ENCLOSURE 2

MFN 03-064

Response to NRC RAI numbers (187, 190, 191, 195, 202, 220,
225, 231, 232, 272, 296, 297, 327, 334–338, 345, 347, 349-
359, 371-376, 378, and 379)

Enclosure 2 RAIs NEDC-33079P “ESBWR Test and Analysis Program Description”

Figure 187A GDCS Equalization Line

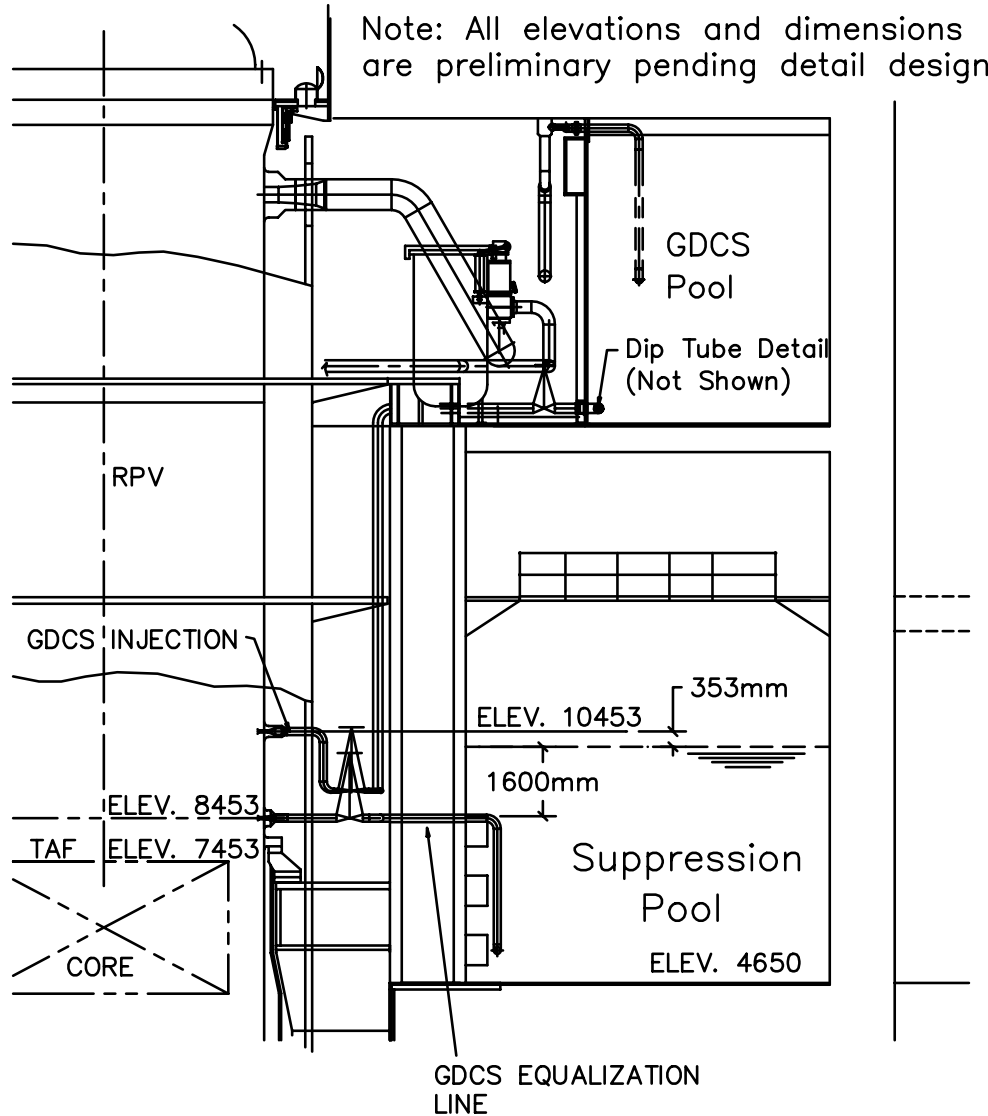
Q187. Page 2-5, Section 2.2.1.2 - For the last paragraph an elevation diagram would be helpful to the discussion.

R187. Please see Figure 187A and Figure 187B for details.

Figure 187B Spillover Hole Configuration

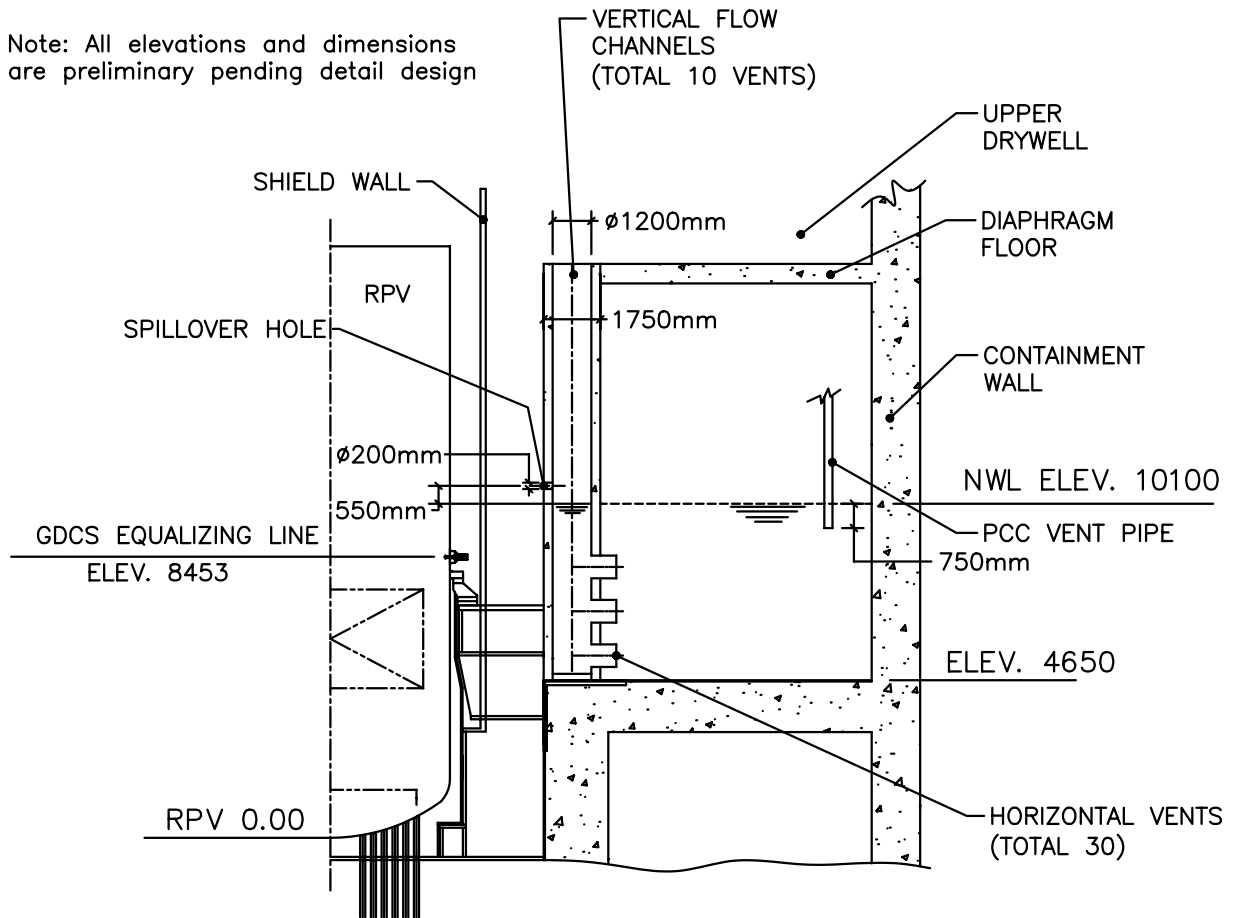
- Q190. Page 2-9 (last paragraph) - It is stated that water collected in the drywell can spill into the wetwell through the spillover holes in the pipes connected to the horizontal vents. Please provide a sketch to show the elevation and diameter of the spillover holes and explain why their presence will not adversely affect horizontal vent clearing in a loss of coolant accident (LOCA).

- R190. Please see Figure 187B (above) for details of the spillover holes. The holes lead from the annular region of the drywell (region surrounding the RPV) to the vertical vents, which lead to the horizontal vents under the water surface of the suppression pool. The spillover holes are 200 mm in diameter and are located about 550 mm above the normal level of the suppression pool water. One hole leads into each of the ten vertical vent pipes. The spillover holes provide a return path for water, which may accumulate in the lower drywell and the annular region of the drywell during a pipe break accident. The purpose of the spillover holes is to provide a means to limit the draw-down of the suppression pool water and thereby assure the PCCS heat exchanger vent submergence. Since the spillover holes are located above the normal water level in the vertical vents they have no impact upon the vent clearing process. The drywell atmosphere pressurizes the vertical vent water column and forces this level down to the first, second and sometimes even third horizontal vents in order to clear the vents and relieve the pressure differential.

Figure 202A ESBWR RPV

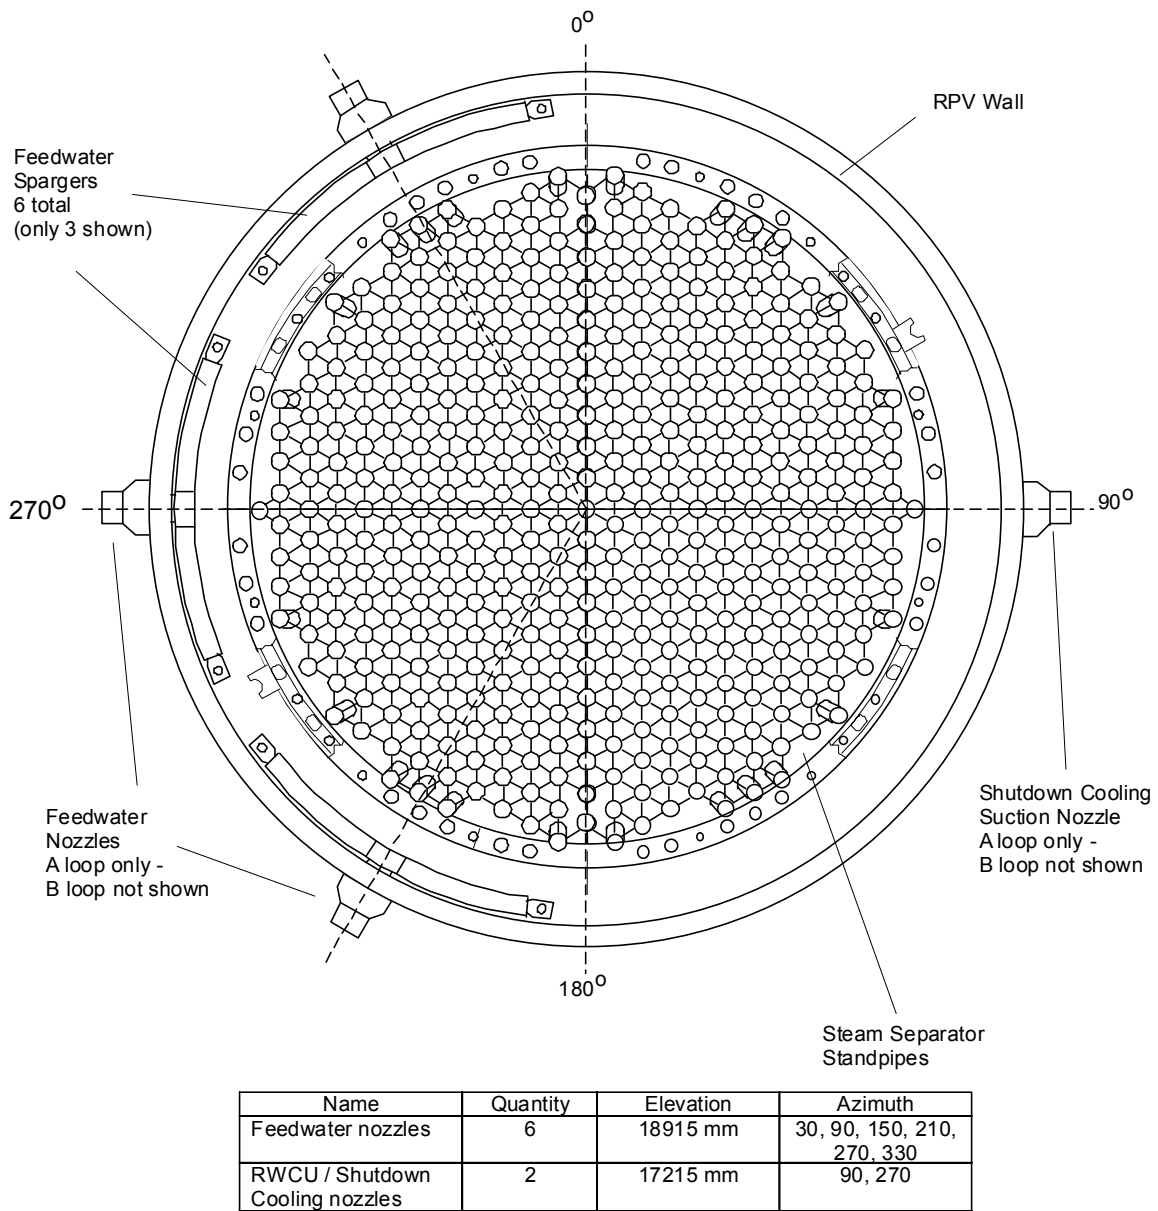
Q202. Page 3-27 (No.2 - B11/4) - It seems that the suction lines of the Reactor Water Cleanup/Shutdown Cooling (SDC) System are connected either to the RPV downcomer annulus or to the RPV bottom head and the injection lines are connected to the RPV via the main feedwater lines. (1) Please provide a sketch to show “inlet and outlet nozzles located diametrically across the downcomer.” (2) There is a typographical error in the fourth column, “CFD code calculations show sort [sic] circuiting will not occur” should be replaced with CFD code calculations show short circuiting will not occur.

R202. Please refer to Figures 202A and 202B for details of the shutdown cooling suction nozzle and the feedwater nozzles.

Figure 353.1. RPV Collapsed Level in Test P1/8

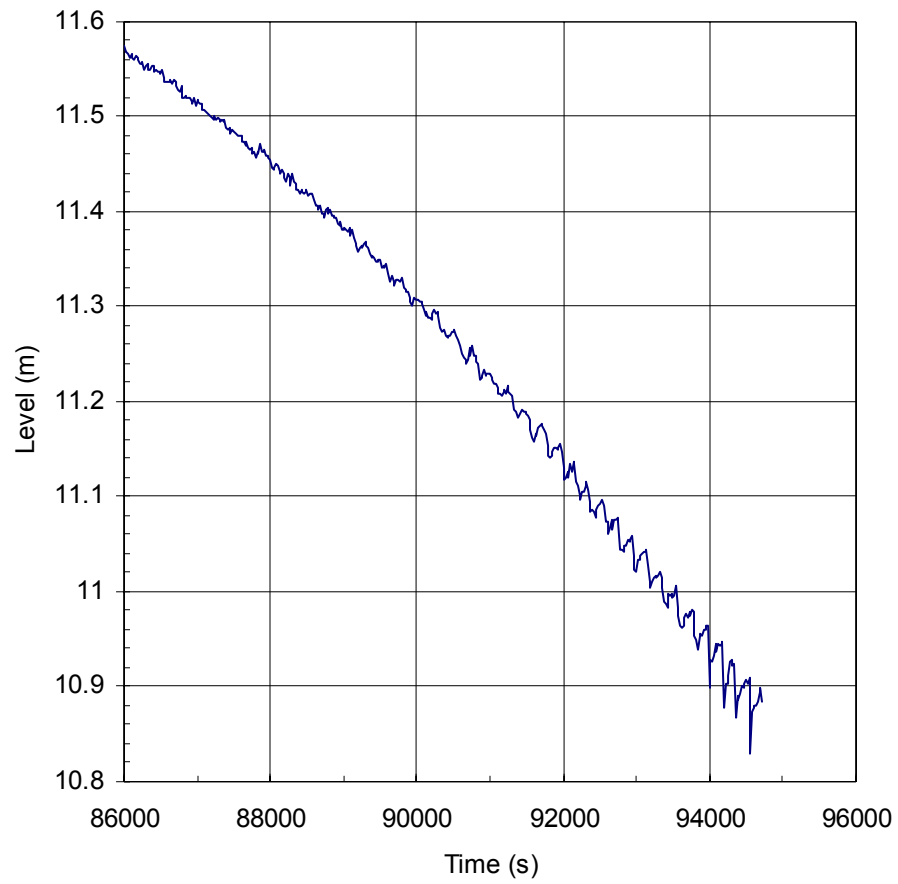
Q353. ALPHA-716-0/Page 20 (Fig. 5). [[

R353. [[

Figure 359.1. Main Vent 1 Instrument Locations

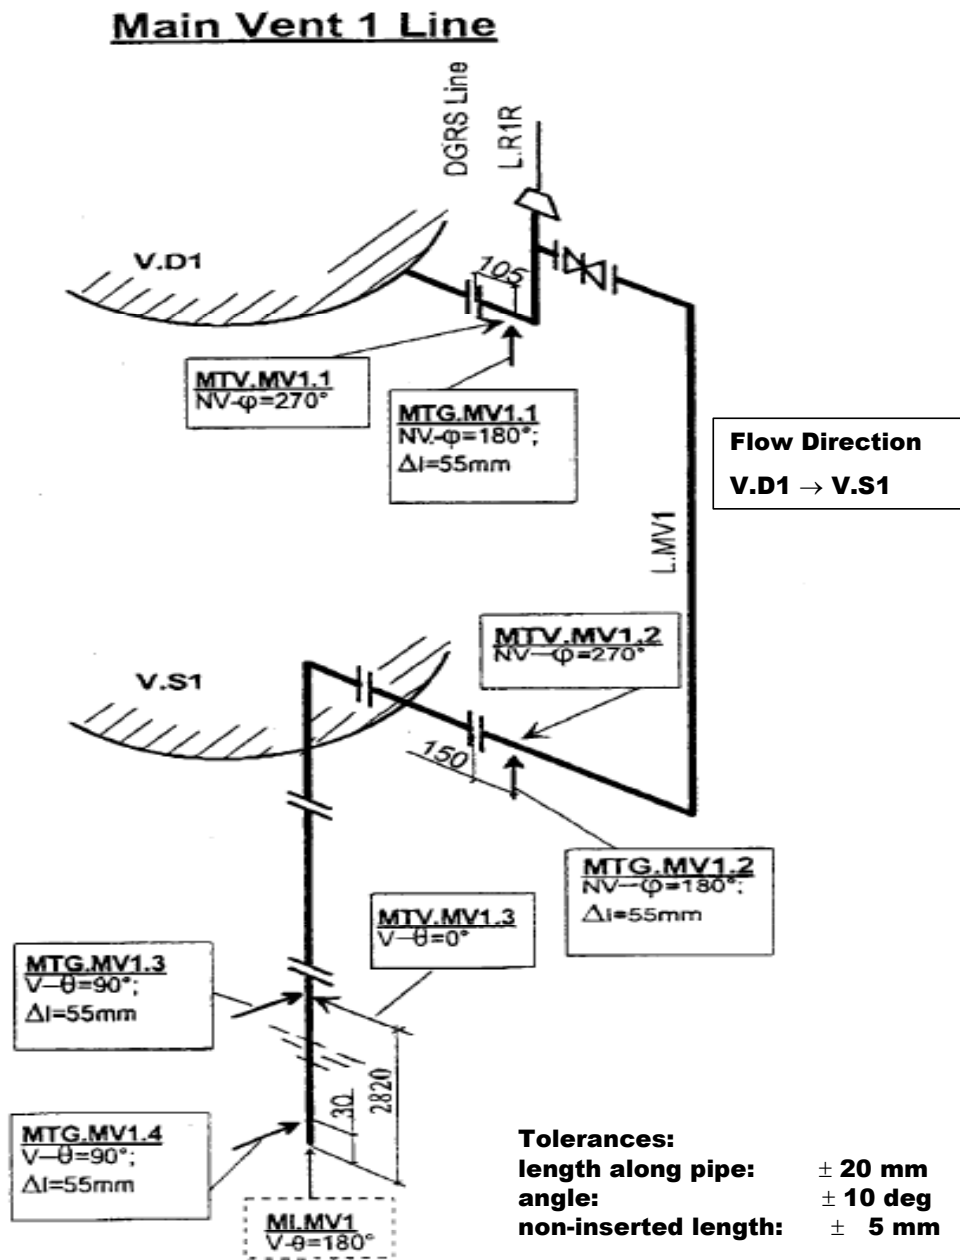
Q359.1. Please provide an instrumentation diagram to show where these main vent thermocouples were located.

R359.1. The main vent instrument locations are shown in Figures 359.1 and 359.2. The thermocouples used to measure gas temperatures are identified as MTG.MV1.1 - 4 and MTG.MV2.1 - 4. Dimensions are in millimeters.
